Donald C. Cook Nuclear Plant Units 1 and 2  
REVIEW OF FOUR PRELIMINARY ACCIDENT  
SEQUENCE PRECURSOR ANALYSES OF OPERATIONAL EVENTS AND  
REVIEW OF DRAFT NUREG "ASSESSMENT OF RISK SIGNIFICANCE  
ASSOCIATED WITH ISSUES IDENTIFIED AT D. C. COOK NUCLEAR  
POWER PLANT"

ATTACHMENT TO C0800-15

INDIANA MICHIGAN POWER COMPANY COMMENTS ON:

DRAFT NUREG ENTITLED "ASSESSMENT OF RISK SIGNIFICANCE  
ASSOCIATED WITH ISSUES IDENTIFIED AT D.C. COOK NUCLEAR PLANT"

**Figure H2 - Event Tree of Revised Analysis of HELB Sequence 1 Scenario B**

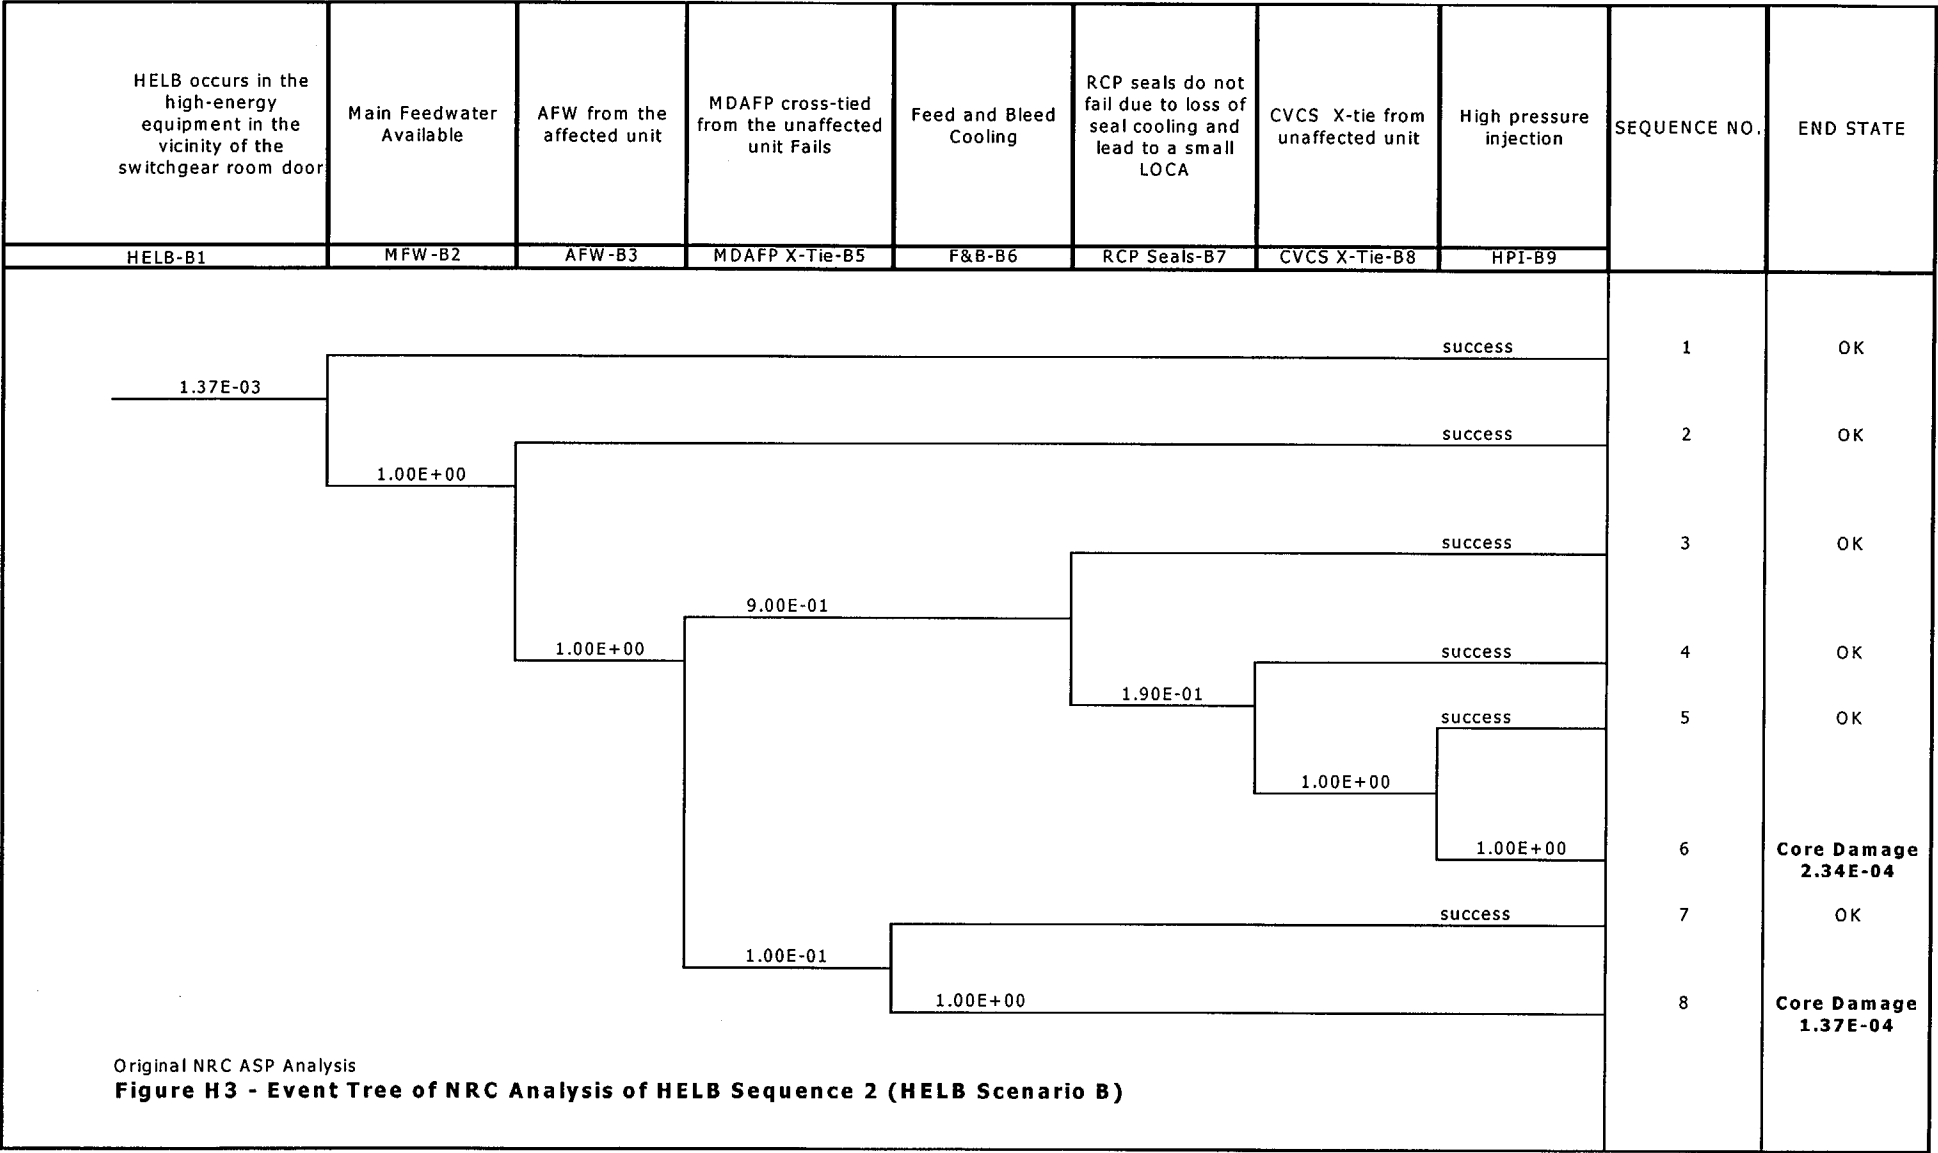
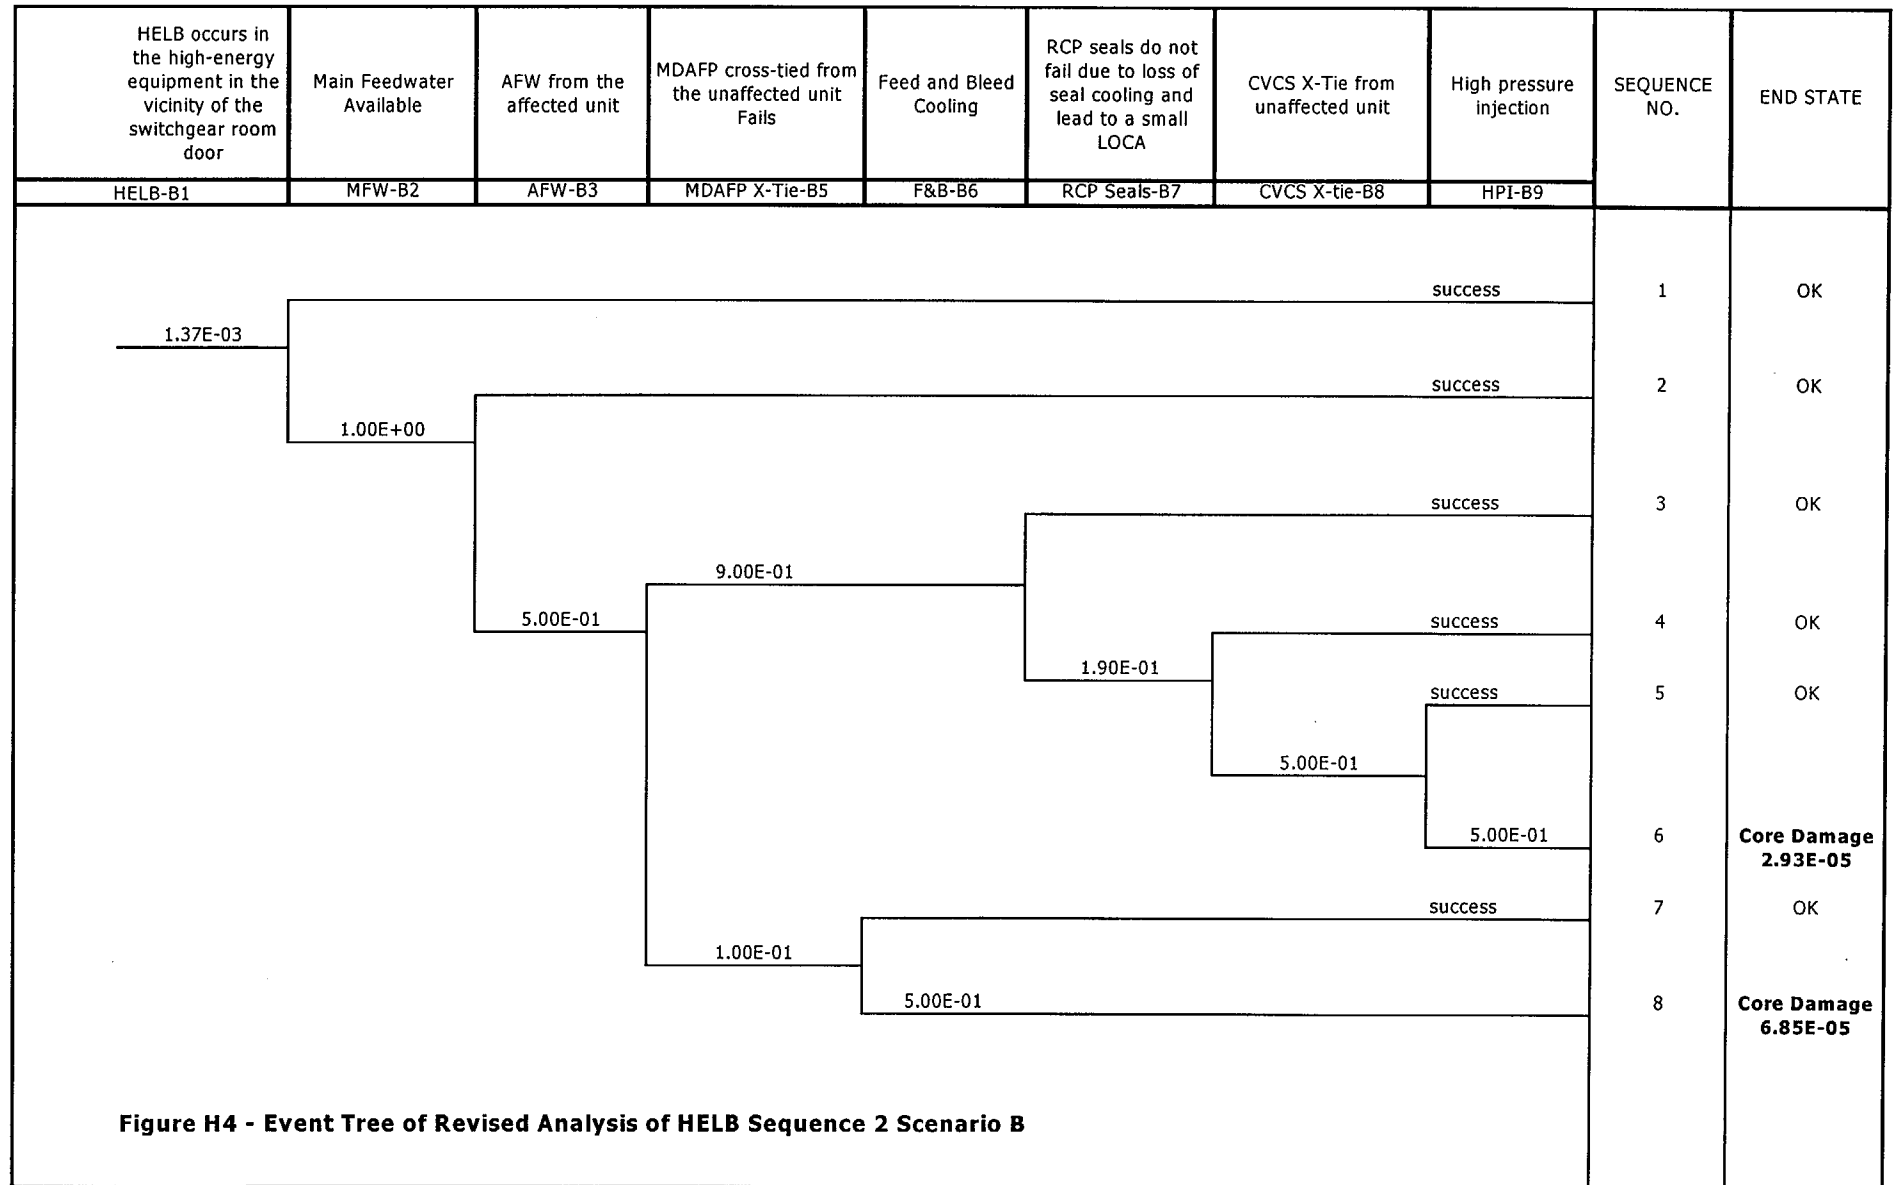
The sensitivity study resulted in the CDF changing from  $1.3 \times 10^{-4}$  to  $1.71 \times 10^{-5}$ . The event tree based on the NRC analysis and the event tree containing the revised event frequency estimates are included as figures H1 and H2, respectively.

The small difference in the values for “HELB occurs in the high-energy equipment in the vicinity of the switchgear room door” between figures H1 and H2 are due to rounding inaccuracies (i.e., the value was recalculated for H2).

In paragraph B1 on Page 6, the estimate of the frequency of HELB events is given as  $1.0 \times 10^{-3}$ . The correct value appears to be  $12.5/1200 = 1.04 \times 10^{-2}$ . The  $1.0 \times 10^{-3}$  value was not carried forward in the CDF calculation, leading to the conclusion that this is a typographical error.
